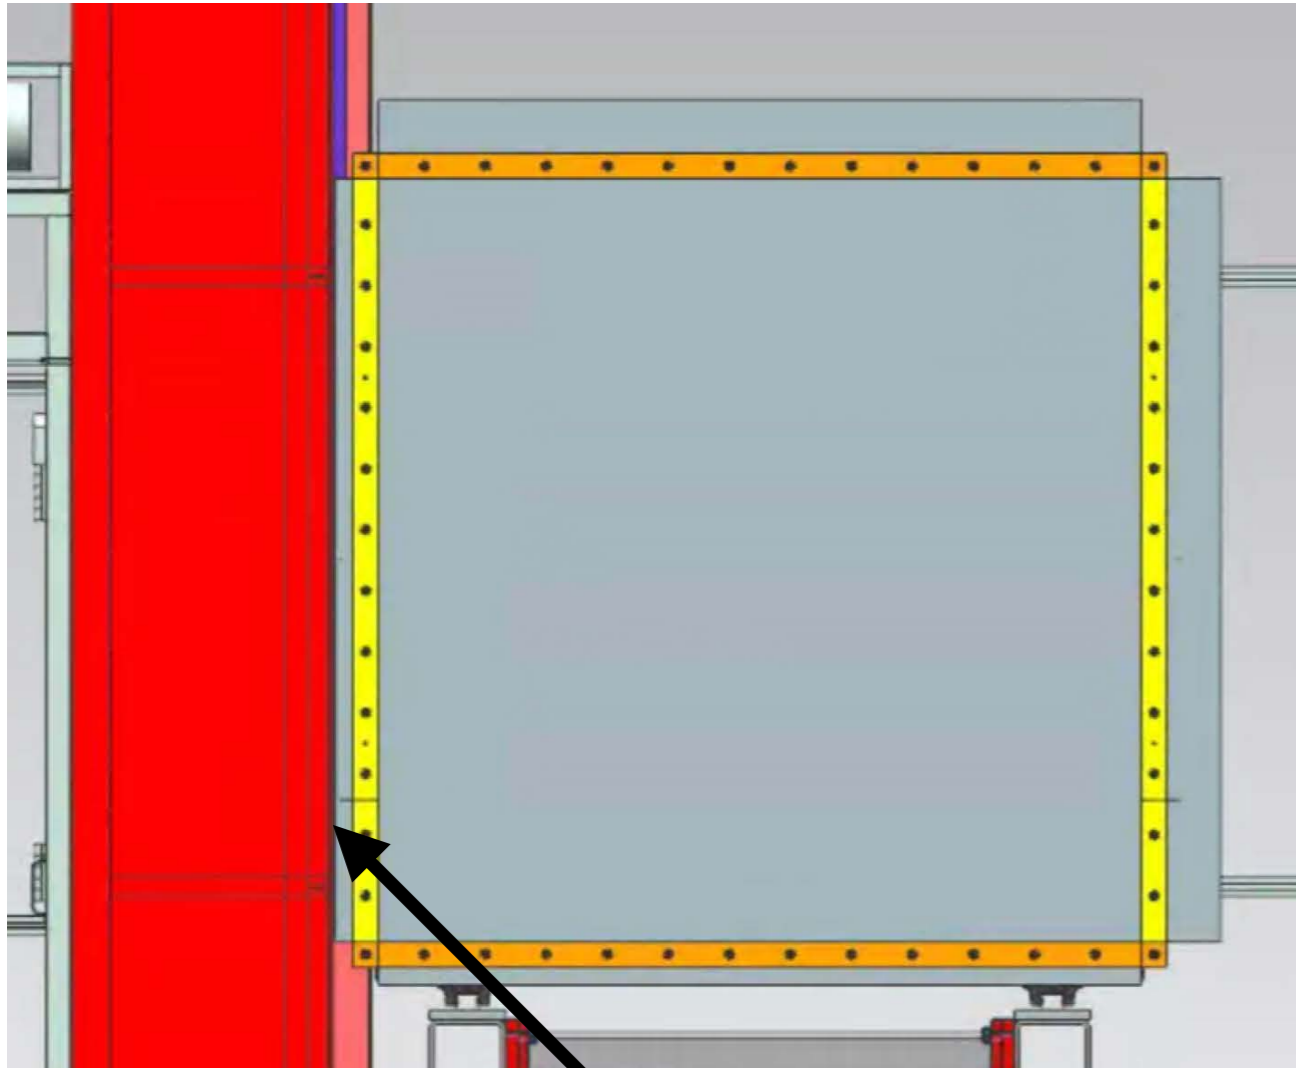
Clearance on beam-right side of the detector for gas lines.

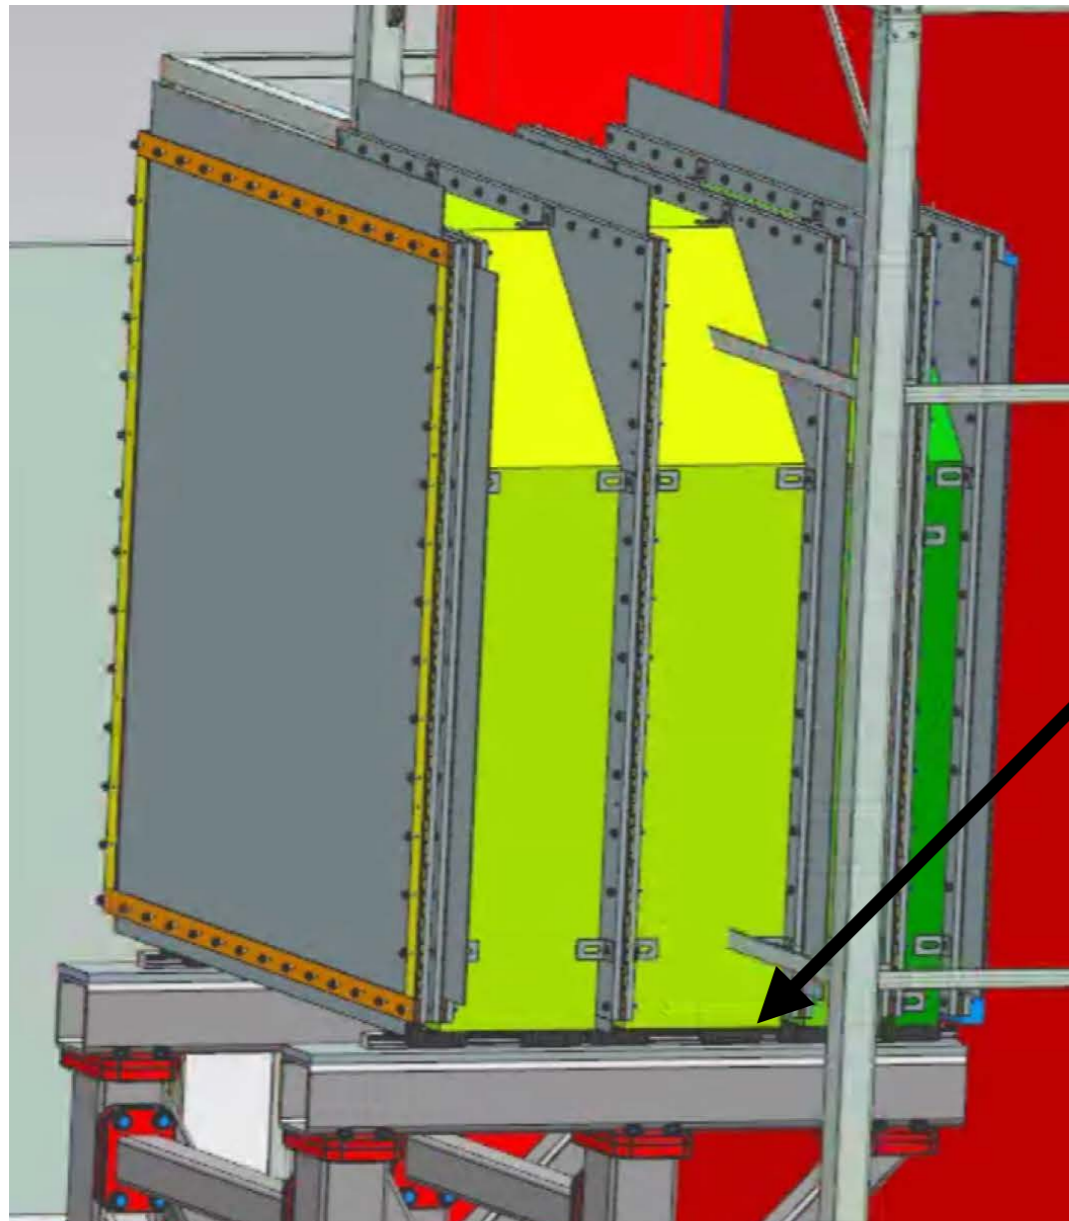
We should check that when the preamp cards are in the horizontal orientation, there's clearance at the bottom of the detector for the gas lines.

Is there a problem here ?
